MEMO

Re: 181 S. High Street, First Review

INTRODUCTION

Figure 1. Looking at the front elevation (left) and north elevation showing rear enclosed porch addition at the northwest corner (October 2020).

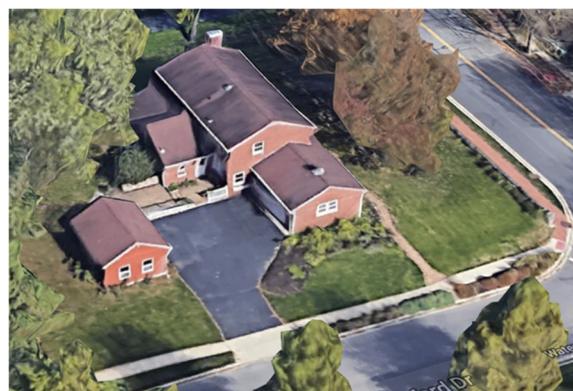
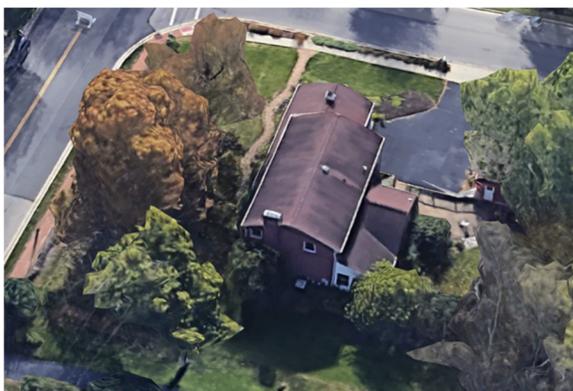
This means the original 1967 house, based on the what currently is visible today, should be kept as-is. Any exterior modifications should ideally be reversible, or if determined necessary by the City of Dublin, destruction of identified original elements should be minimized. Modifying the 1967 structure and architectural elements previously called out to create a farm-house aesthetic would create a false historicism that no longer informs the district's richness of character. “All buildings, structures and sites shall be recognized as products of their own time. Alterations that have no historical basis and which seek to create an earlier appearance inconsistent or inappropriate to the original integrity of the building shall be discouraged,” (ARDC 15.174). The original farmhouse sits next door, at 167 S. High Street. It is important to maintain the history of the area by not upstaging this farmhouse with incompatible buildings (see Figures 6 and 7 for a graphic depiction on a detail site plan).

However, this assessment does not prohibit changes to the exterior. Removal of the enclosed porch is permissible, and adding additions are permitted, provided:

Regarding the demolition and replacement of the attached garage, this garage represents the standard dimensions used in 1967 for car vehicular storage. Today's vehicles probably have the similar length to the larger American cars of the Fifties and Sixties, but not the height and widths found with today's SUVs and extended cab pickups. Without knowing the client's specific vehicular needs, this reviewer recommends keeping the original garage as intact as possible and searching for alternate design possibilities that meet the above criteria.

As far as the repair, replacement and/or repainting of the exterior brick and repointing the mortar is concerned, this brick and its mortar are character-defining features, and as such should be retained and preserved as much as possible on the original 1967 house. While there may be some difficulty in matching historic brick and mortar, the National Park Service has published various bulletins on this subject that can be of help. Overall, it is recommended to repair and maintain the brick if possible.

Figure 4. Overall view of the buildings south of Bridge Street with the existing building, outbuilding and driveway shown in blue. (Original Adobe Illustrator sketch using ArcGIS Data provided by the Franklin County Auditor and the City of Dublin, extracted September 9th, 2020; not to scale)

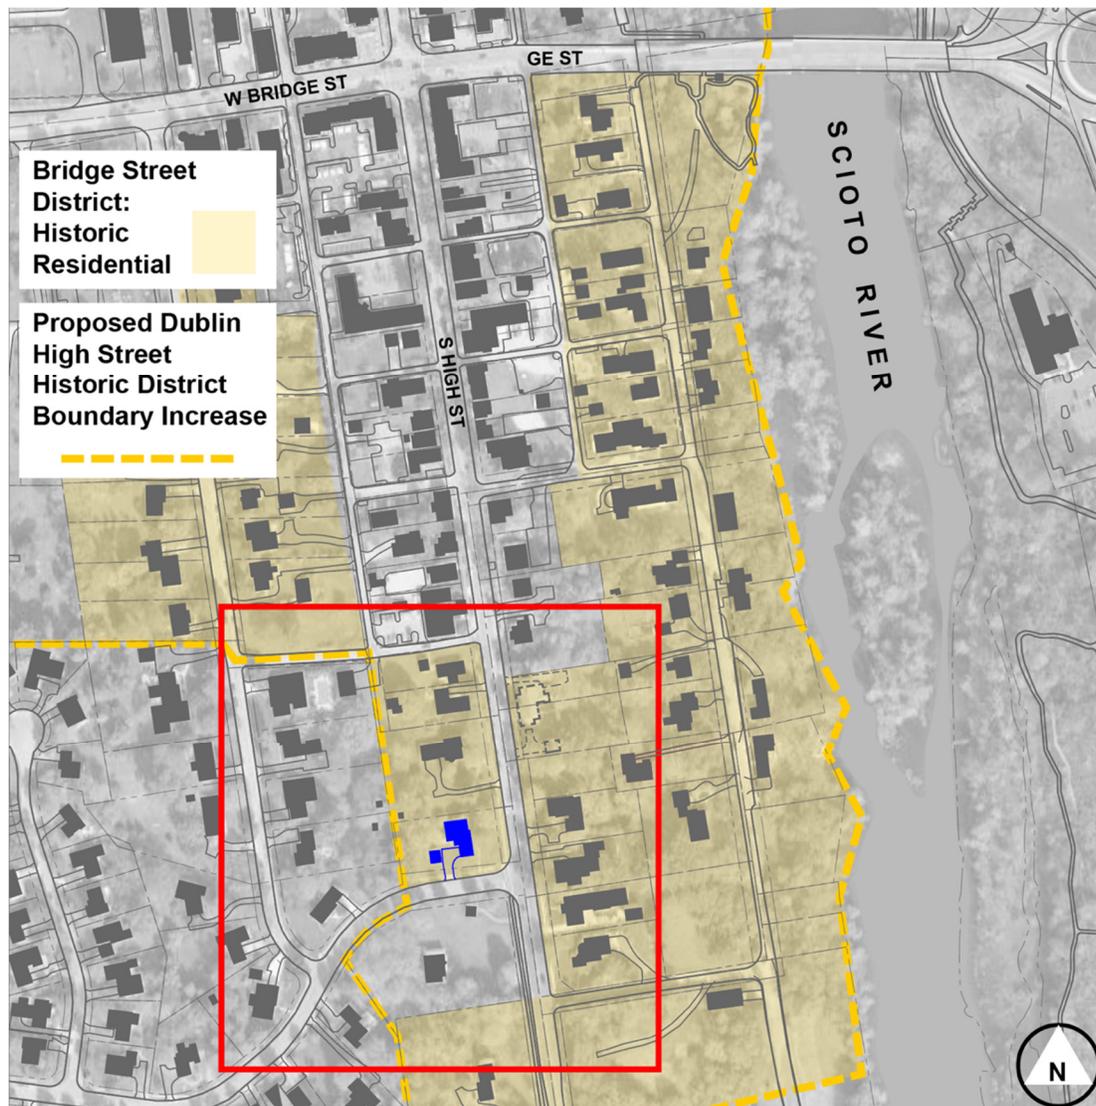
Regarding the massing and look of the additions, the architect must balance the program needs while maintaining the characteristic footprint of the BSD: Historic Residential zoning district. Per the overall site plan (Figure 4), any new additions should not oversize the house's footprint in comparison with

nearby properties. Design solutions can also be found by creating compatible additions that are reversible. The architect may wish to examine extending the front porch in a reversible and minimal way, or to add a patio with compatible landscaping to the north end of the east elevation so as to meet program requirements while supporting the original architectural style.

Figure 7. This shows the proposed site plan with the original building portions that remain generally intact as gray, and additions to the original structure as black. Again, this proposed plan requires modification to comply with recommendations.

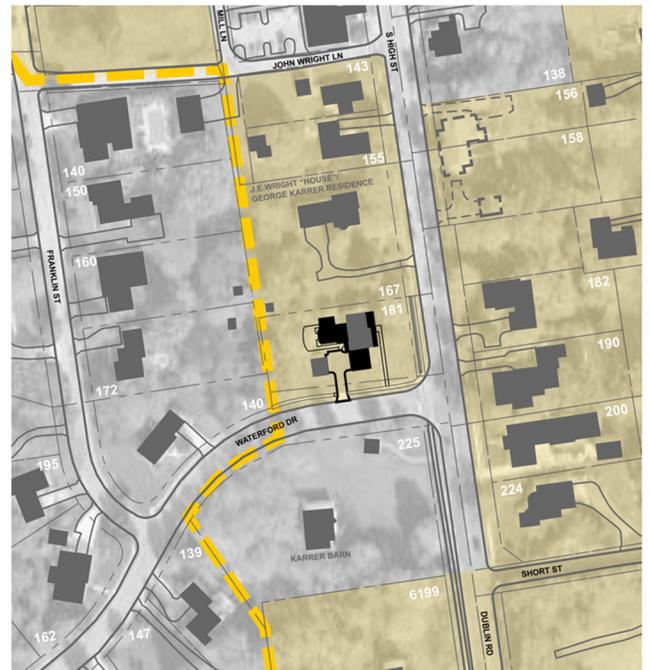
Figure 5. Proposed Site Plan with Building Interior of the proposed Bergwall Residence by Richard Taylor Architects. Note that this site plan requires revision to comply with the design recommendations, including keeping the original garage and keeping the east façade intact.

Figure 6. Existing building on the site showing the original building portions to remain in blue and portions to be demolished in red, per the proposed site plan shown in Figure 4. This proposed plan requires modification to comply with recommendations.

Overall, I would **not approve the current design without modifications** as currently presented. It requires some simplifying in plan, removing false historical elements, and maintaining the original architectural style's character defining elements on the east and south elevations. While some materials and finishes are acceptable (such as the asphalt shingles), others need to be revised to comply more completely with the historic preservation standards, such as keeping the original brick and mortar and not installing board and batten siding on a residence.
